Best of December 2020

The following are a dozen questions answered by the NFSA's Codes, Standards, and Public Fire Protection staff as part of the Expert of the Day (EOD) member assistance program during the month of December 2020. This information is being brought forward as the "Best of December 2020." If you have a question for the NFSA EOD submit your question online through the "My EOD" portal.

Question #5 - Drain Piping

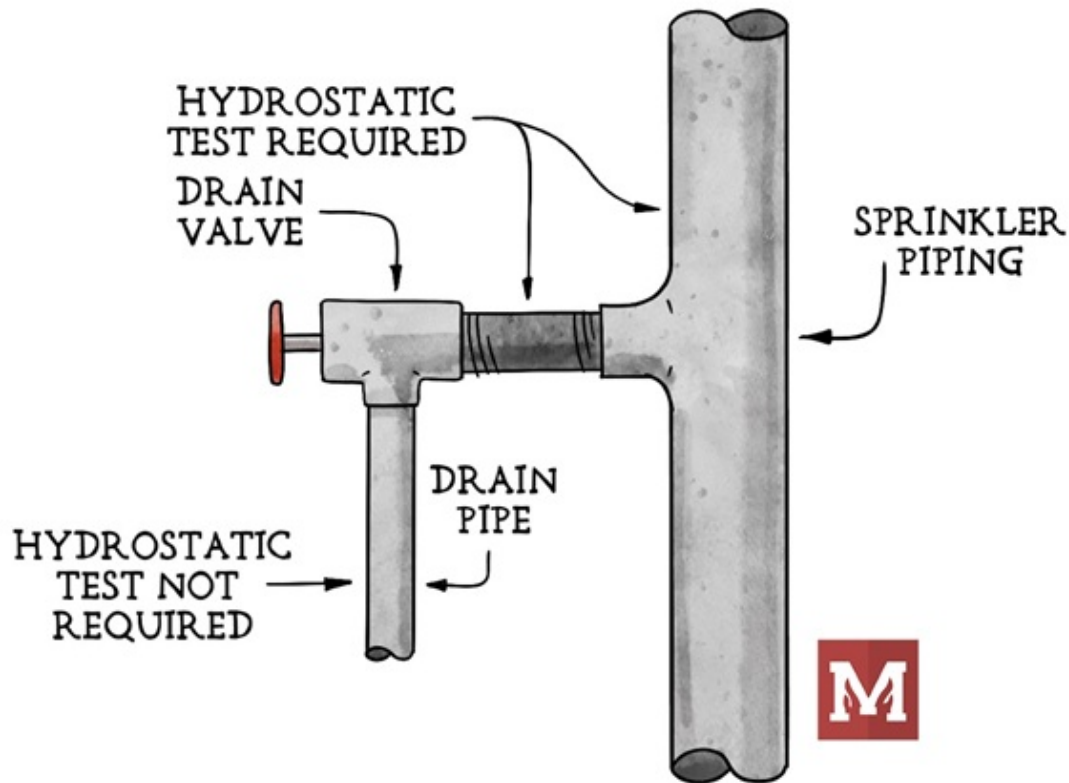
Does drain piping need to be hydrostatically tested? The authority having jurisdiction failed a hydrostatic test in a high rise because it did not include the drain piping with the testing.

Yes, drain piping is required to be hydrostatically tested but only the sections that are subject to system working pressure. Section 25.2.1.1 of the 2016 edition of NFPA 13 states that all piping and attached appurtenances subjected to system working pressure are required to be hydrostatically tested. The portion of the drainpipe subject to normal system working pressure (i.e., up to the closed drain valve) would be required to be tested. However, the drain piping beyond the closed drain valve is not subject to normal system pressure and would be exempt from testing.
